V2500-A5/D5 SERIES PROPULSION SYSTEMS SERVICE BULLETIN

This document transmits Revision 1 to Service Bulletin EV2500-72-0481 and Revision 1 to the Supplement

ENGINE – HP COMPRESSOR BLADES – INTRODUCTION OF A PART NUMBER TO RE-IDENTIFY EDM
MANUFACTURED STAGE 3 BLADES

Family Tree - HP Compressor Stage 3 Blade
Figure 1

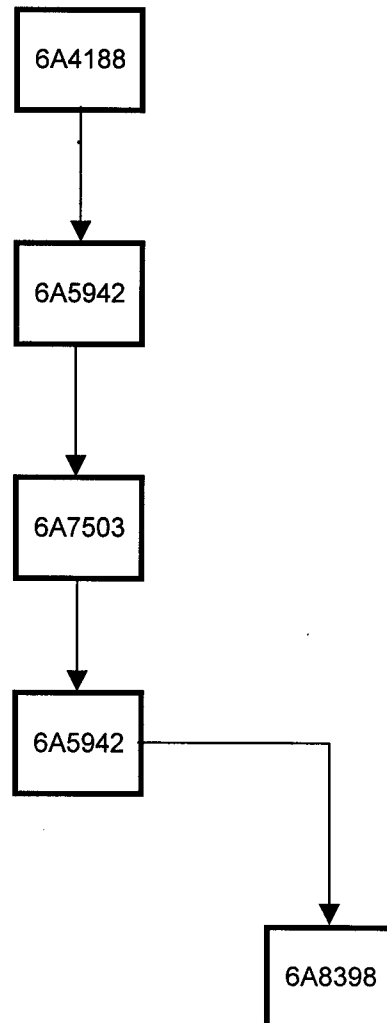
V2500-ENG-72-0481

Engine - HP Compressor Blades - Introduction Of Part Number To Re-identify EDM Manufactured Stage 3 Blades.
